ST. JOHN'S ORTHODOX CHURCH
 7530 Mohawk Road
 Colorado Springs, CO

FINAL LANDSCAPE PLAN

SHEET NO. **L1**
 Sheet 1 of 2

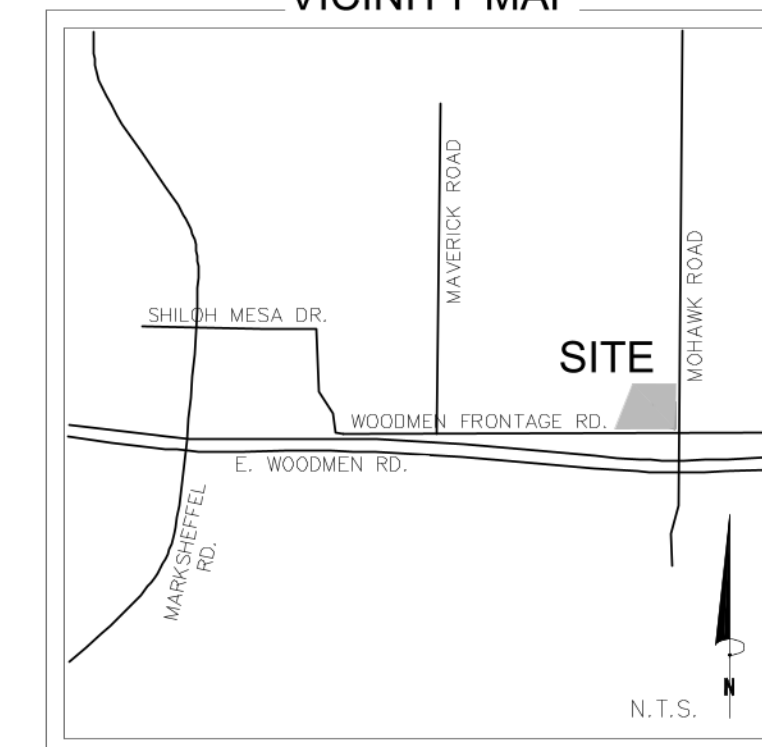
Please site in the letter of intent you are proposing an alternative landscape plan and the justification

Should have fencing, plantings with a buffer, due to request of alt. they are not shown

Trees need to break up or divide up parking spots

Please provide sight distance triangle setback

Please include: owner/ applicant contact information
